PIC18C601/801 Rev. B1 Silicon/Data Sheet Errata

The PIC18C601/801 parts you have received conform functionally to the Device Data Sheet (DS39541A), except for the anomalies described below.

Clarifications/Corrections to the Data Sheet:

FIGURE 1: INTERRUPT LOGIC (EXCERPT)

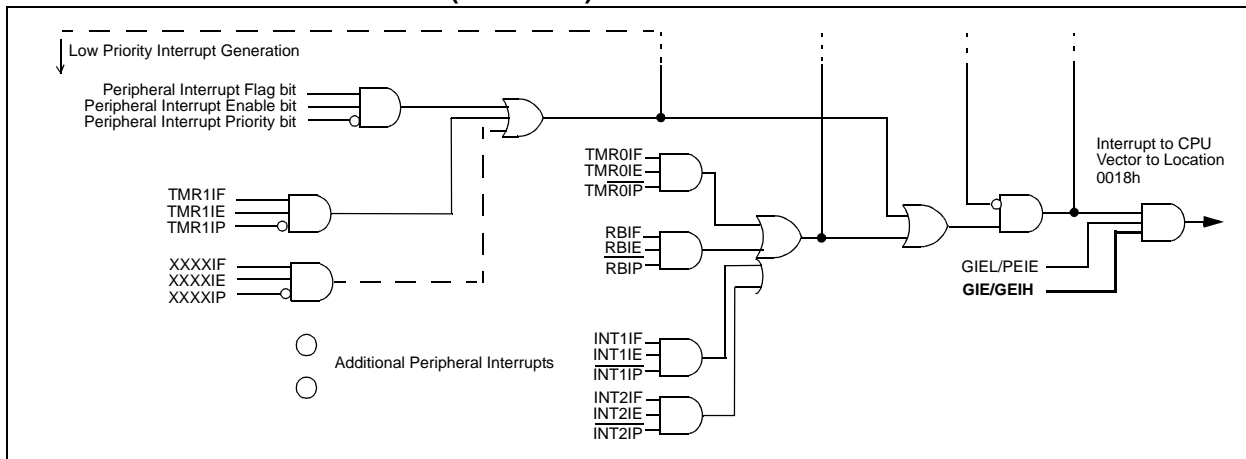
The operation of the GIE/GIEH bit (INTCON<7>) is clarified as follows: when the bit is cleared, all interrupts are disabled. This is regardless of the state of the IPEN bit (RCON<7>), the priority of the interrupt, or whether or not the interrupt is

unmasked. This varies from the original description, in which clearing the bit when IPEN = '1' would only disable high priority interrupts.

Also, the interrupt logic funnel shown in Figure 1 of the Device Data Sheet is amended with the addition of a GIE/GIEH control line, as shown in Figure 1 (new material in **bold line**).

FIGURE 2: PIC18LC601/801 VOLTAGE-FREQUENCY GRAPH (INDUSTRIAL)

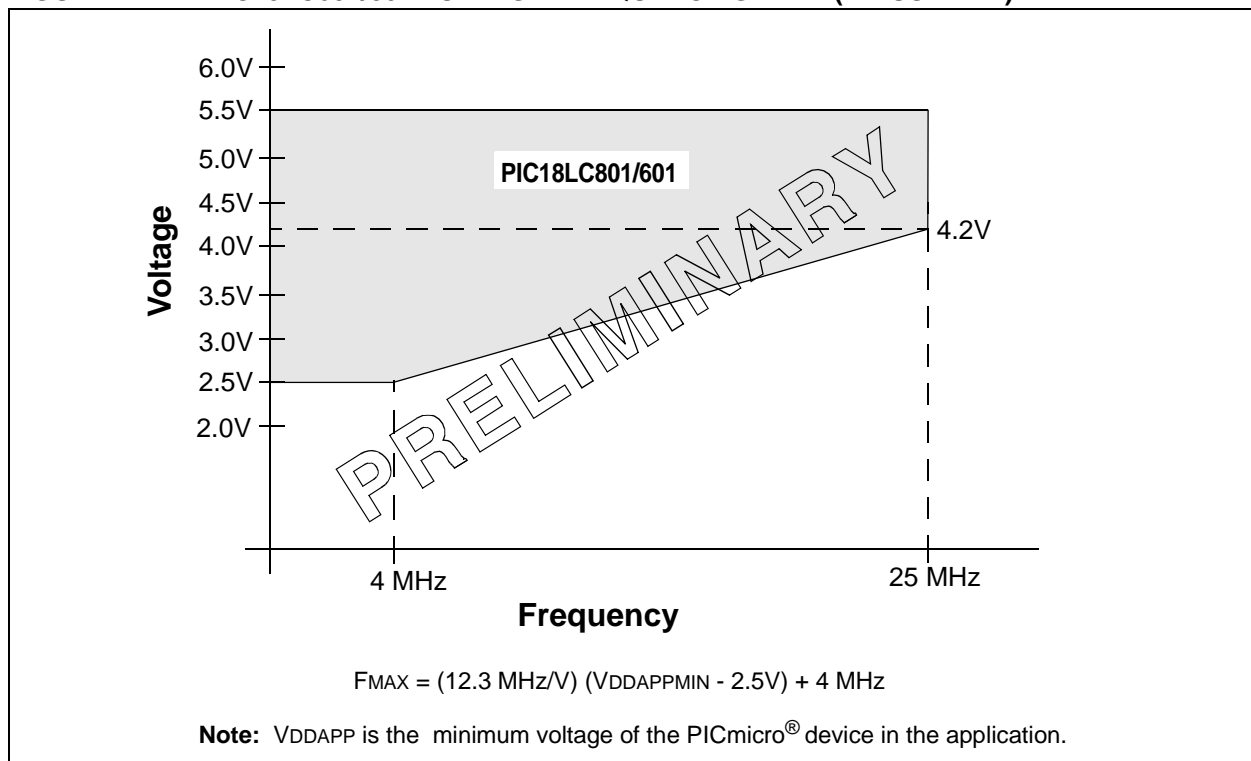
The minimum value for parameter specification number D001 (VDD) for extended voltage range devices has changed from 2.0V. The new value is shown in Table 3.

Because of this change, the voltage vs. frequency graph for extended voltage range devices has been modified. Figure 22-2 of the Device Data Sheet is replaced with Figure 2, below. This also clarifies that the graph refers to extended voltage range (“LC”) devices.
